## APPENDED HEALTH AND SAFETY PLAN FOR TASK ORDER 1

### RCRA Facility Investigation/Corrective Measures Study (RFI/CMS) and Base Closure Environmental Study for the Lexington-Blue Grass Army Depot

Contract No. DAAA15-90-D-0016  
Task Order Number 4

October 24, 1991

Figure  
 3-1

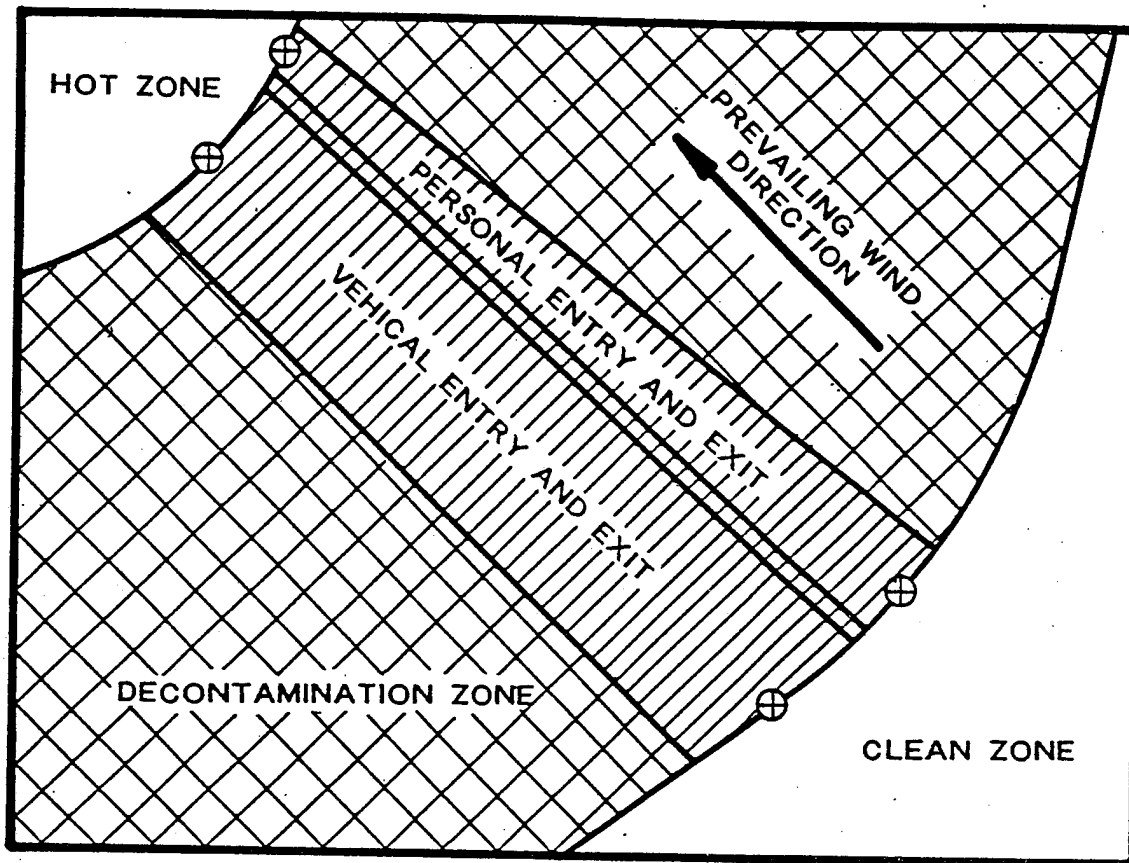
**Change:** Insert "Figure 3-1 is an example of Work Zone Designation" as the 3rd Paragraph.

**Change:** Insert Figures 3-1 and 3-2.
